Development Management – Delegated Officer Report

Application Number:	AWDM/0228/26	Recommendation - Approval
Site:	Former Mannings, Surrey Street, Shoreham-by-Sea, West Sussex	
Proposal:	Application for a Non-Material Amendment following approval AWDM/1281/19. Amendments: 1, Introduction of vents on the North and West elevations and adjustments of louvres to external doors; 2. Introduction of a cooling unit on the fifth-floor maintenance roof required in connection with UPS room at GF level in connection with the introduction of two smoke shafts within the building to comply with the fire strategy; 3. Adjustments to GF landscaping and coordination of levels to comply with the fire strategy and Building Regulation requirements; 4. Revised material schedule accounting for alternative use of glazed tiles to entrance areas; 5. Introduction of brick piers/walls at ground and first floor level to southern elevation and ground to third floor levels at western elevation to support fire rated brick screens to inset balconies; 6. Revised vehicle entrance gate design;

Figure 16 - Northern Elevation (submitted plan)

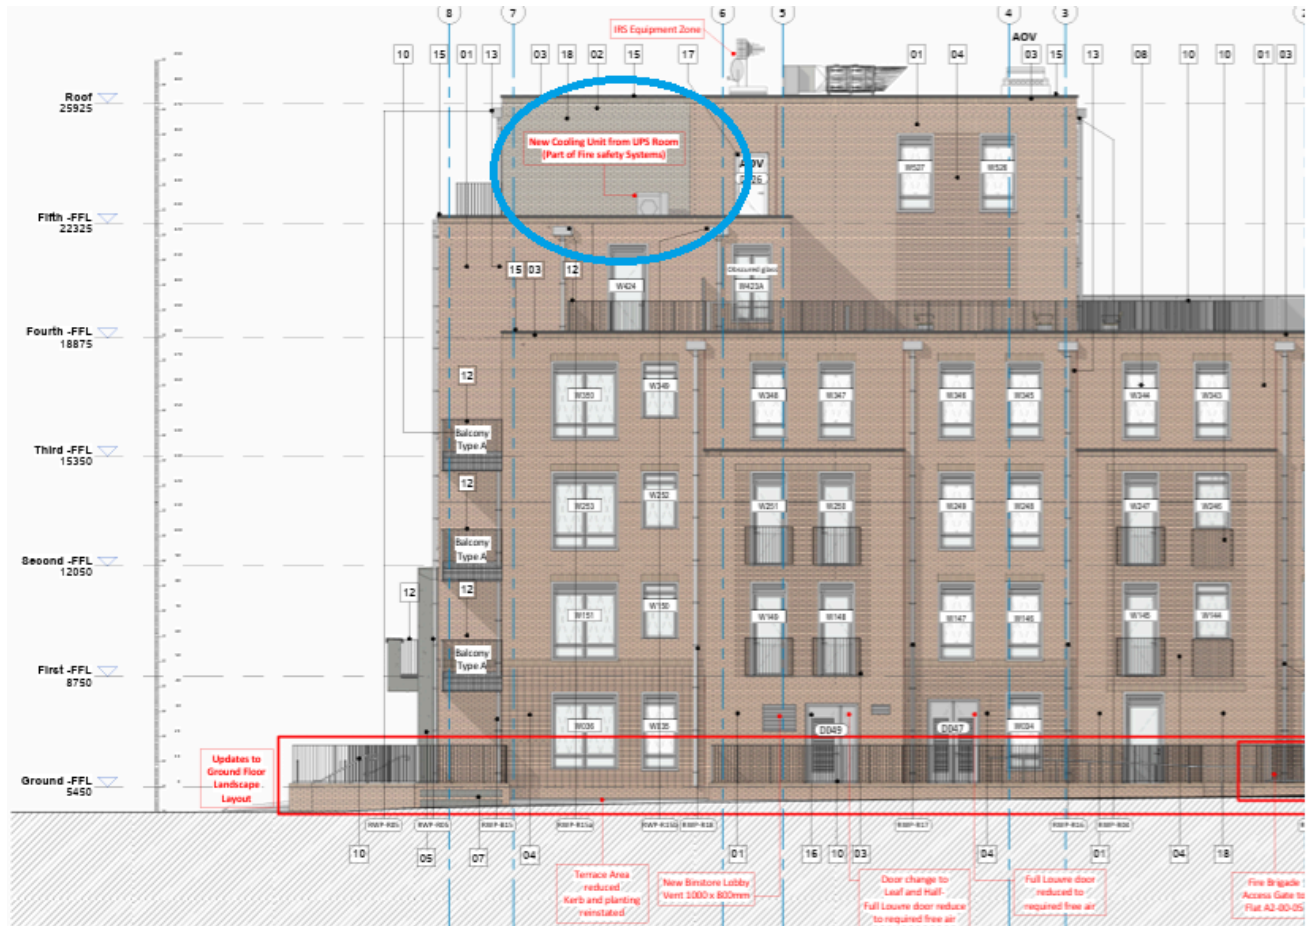
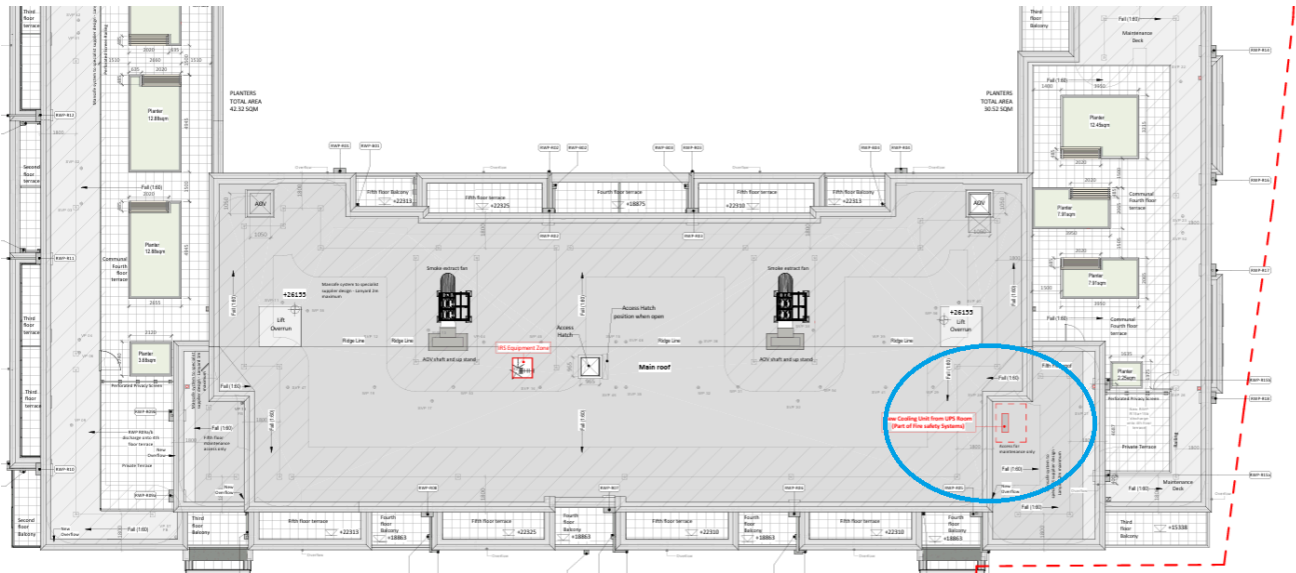
The proposed air-conditioning unit is proposed to be positioned atop the 5th (penultimate) storey of the proposed building and to the northern edge of the 6th storey layer. The positioning of this feature is shown at **Figures 16 and 17** below.

The air-conditioning unit is considered to be sensitively positioned, being masked by approved built-form at 6th storey level to the east and south. The unit, further, is shown positioned some distance inset from the 5th storey parapet such that equipment of the height indicated would unlikely prove visible within close proximity to the approved building. The visual effect of this addition, therefore, is deemed to be acceptable.

In terms of acoustic effect, the proposed air-conditioning unit is of domestic specification and positioned away from any window or balcony serving an individual unit. It is not expected, therefore, that the introduction of this unit would adversely influence the living conditions of future occupiers or require additional acoustic insulation beyond that previously approved.

Figure 18 - Eastern elevation (submitted plan)

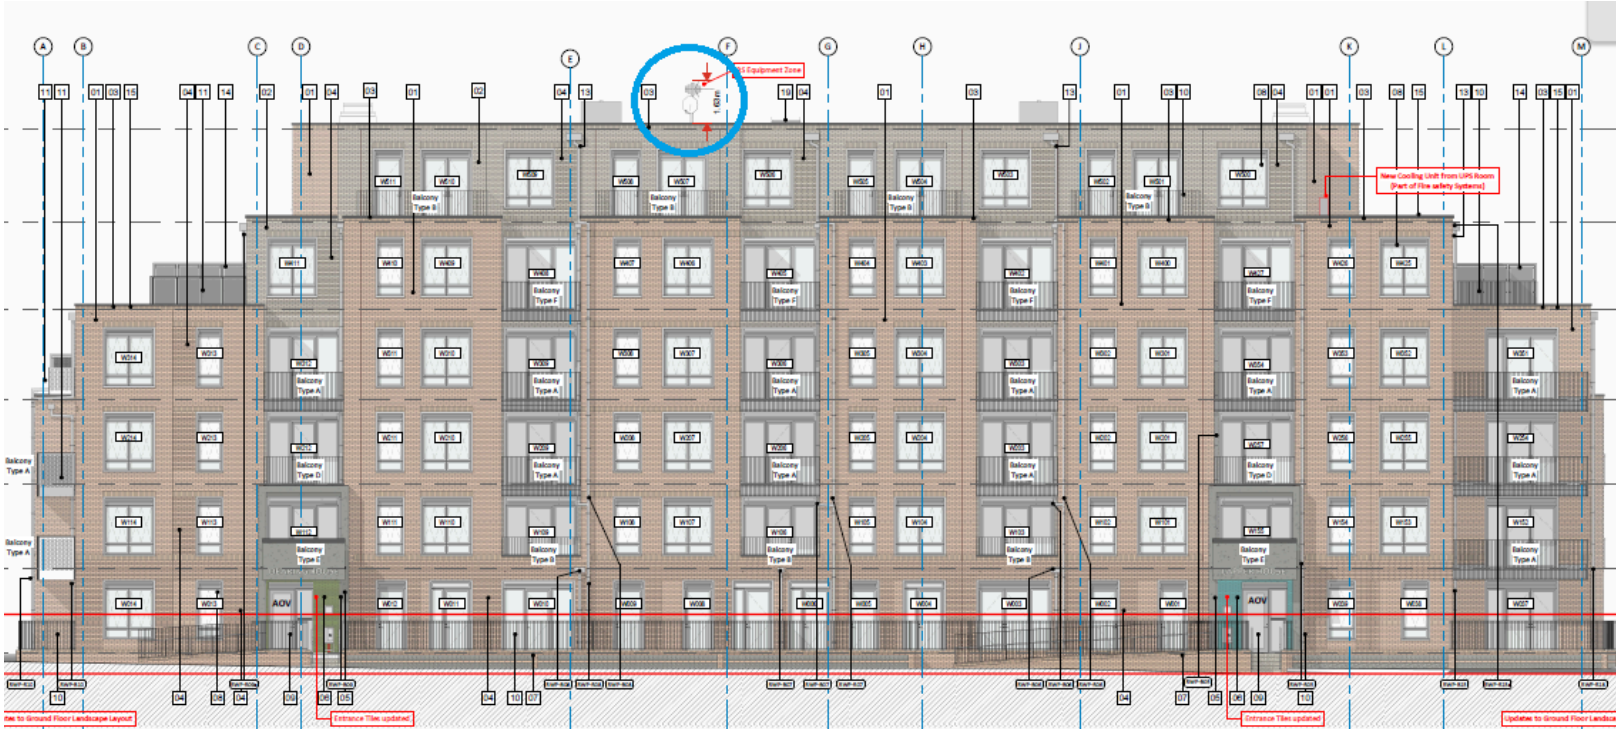
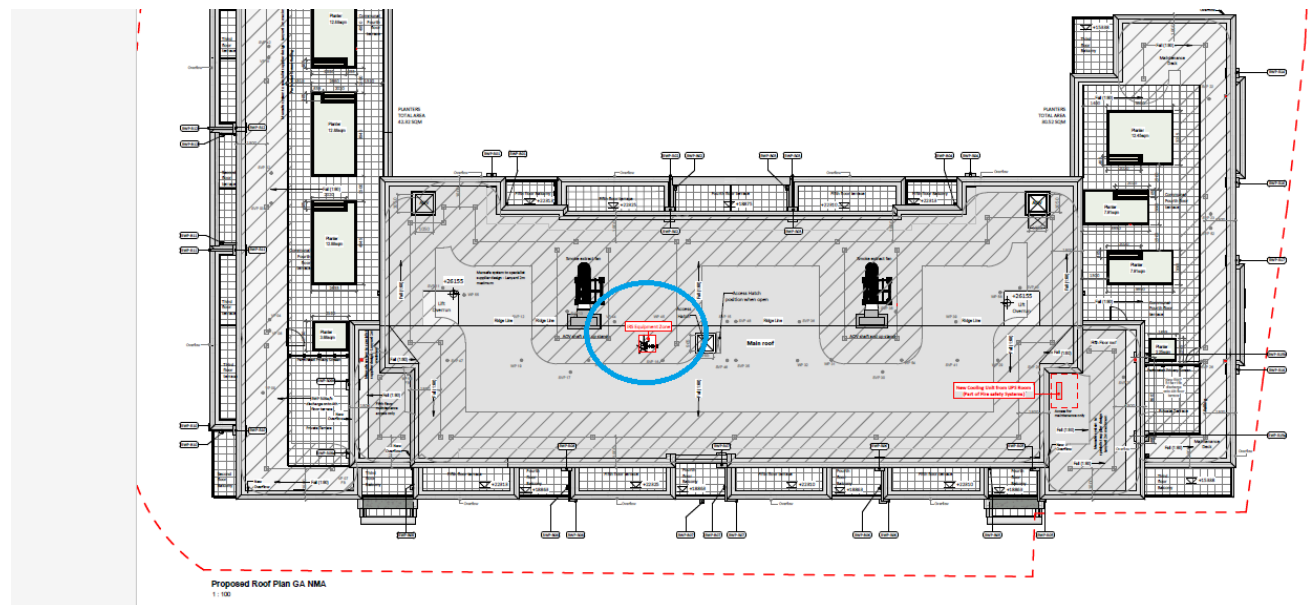
The proposals include the addition an Integrated Reception System (IRS) antenna atop the approved 6th storey rooftop. The submitted plans show this as a single centrally positioned antenna which would project a maximum of 1.65m above the approved parapet and positioned. This is shown at **Figure 18** relative eastern elevation of the approved building and at **Figure 19** relative to the approved roof-plan.

A rooftop feature of this height above the 6th storey parapet is expected to prove visible within medium and longer distance views. The submitted plans, however, do show the antenna as a lightweight feature which is considered to be of lesser bulk and massing compared to the rooftop smoke-extract equipment previously approved by NMA pursuant to ref: AWDM/1284/25, notwithstanding its greater height.
